ITEM 8. DEVELOPMENT APPLICATION: 1 DARLING STREET GLEBE

FILE NO: D/2009/1773

Summary: The application proposes a new front dormer, rear roof extension and ground level internal alterations.

Figure 6 – Proposed rear (Northeast) elevation (as amended).

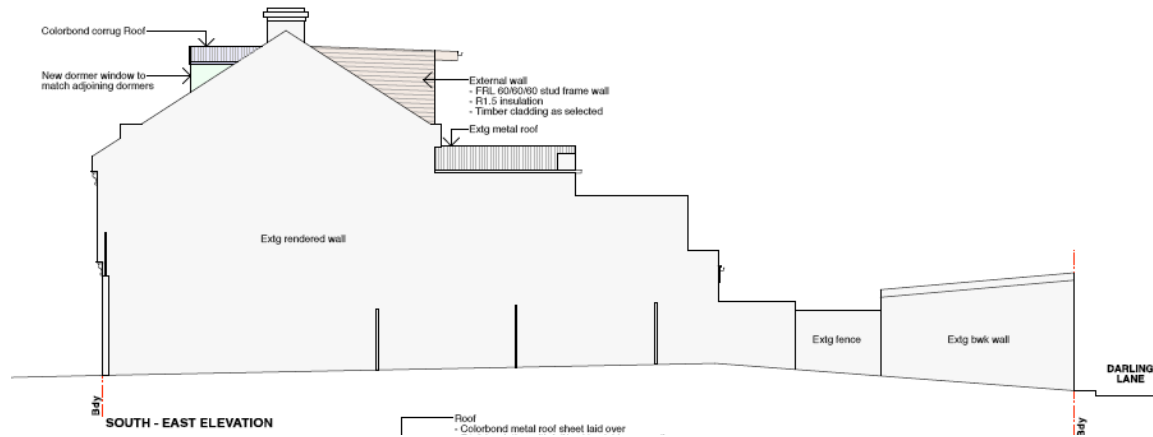
21. The proposed rear roof extension generally matches the existing and approved rear roof extensions of the adjoining terraces to the north. The extension has been amended to reduce overshadowing impacts and provide a more complying built form. See Figures 6 to 8 below.

23. Although not complying with the side setback requirements, the proposed rear extension is considered acceptable as the roof form is consistent with the existing and approved additions to the north at Nos. 3 to 7 Darling Street (see Figure 6). The proposal maintains the most intact rear feature of the row being the strong rhythm of the second storey gable ended rear wings.

Figure 7 – Southeast (side) elevation (original proposal).

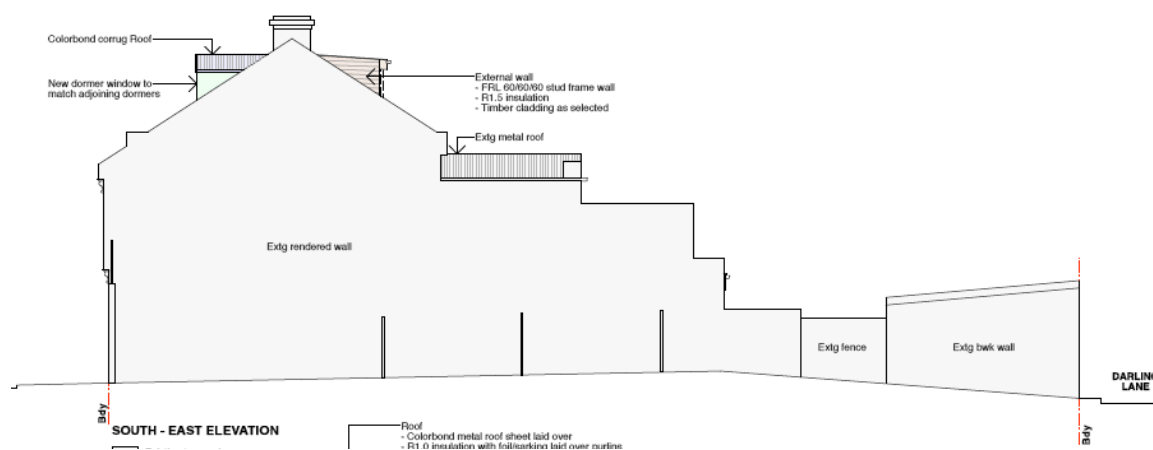
22. The extension is set below the ridge and from the rear of the roof slope in accordance with the requirements of the Heritage DCP. The proposed setbacks from the side walls are 150mm which is less than the 500mm recommended by the DCP. The intent of the control is to ensure that the main roof form of terraces remains legible.

Figure 9 – Rear of Nos. 9 – 13 St Johns Road, taken from the second storey deck of subject site.

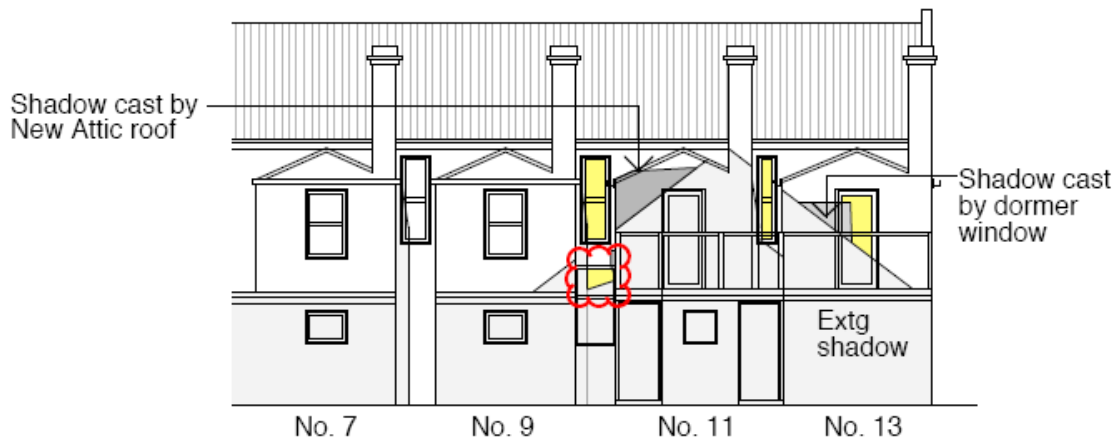
28. Shadow diagrams are included at Attachment B and show the existing and proposed shadows at the Winter solstice in hourly intervals.
29. At the ground floor, except at 9.00am, the rear facing openings of Nos. 11 and 13 are currently in shadow all day. The proposal does not result in any additional overshadowing to the ground floor openings.

30. At the second storey, between 9.00am and 12 noon, the openings are mostly in sunlight. The proposal does not result in any additional shadows during this time.

31. Minimal shadows are cast from the proposal between 1.00pm and 2.00pm. At 1.00pm, a negligible shadow is cast on the door to No 11's deck. At 2.00pm, the front dormer casts a minor shadow (0.12m²) over No. 13's window.

Figure 12 – Amended envelope of rear roof extension shown in red and dashed.

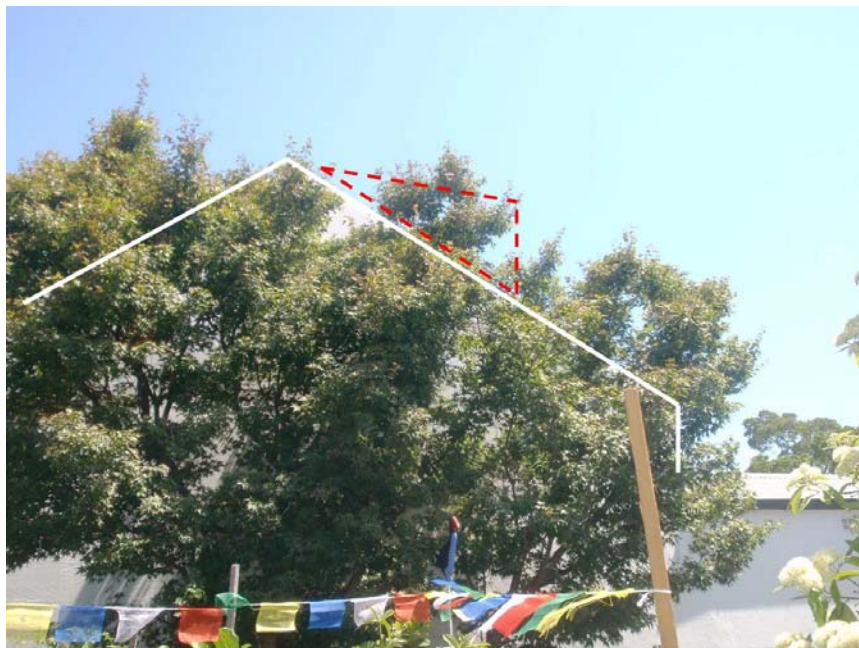
33. Under the Leichhardt DCP, one of the principles relating to access to views includes ensuring views and vistas are protected. One submission received from the neighbouring property to the southeast, No. 13 St Johns Road, raises concern about the loss of sky views. A photo taken from the second storey deck is at Figure 12 below.

34. The proposed addition will affect some of the sky aspect that Nos. 11 and 13 currently enjoy when looking directly towards No 1 Darling Street. Notwithstanding that the existing sky view is mostly concealed behind a tree, the proposal has been assessed having regard to view loss and is considered acceptable as the side wall that obscures sky views is limited to an area under 1m².
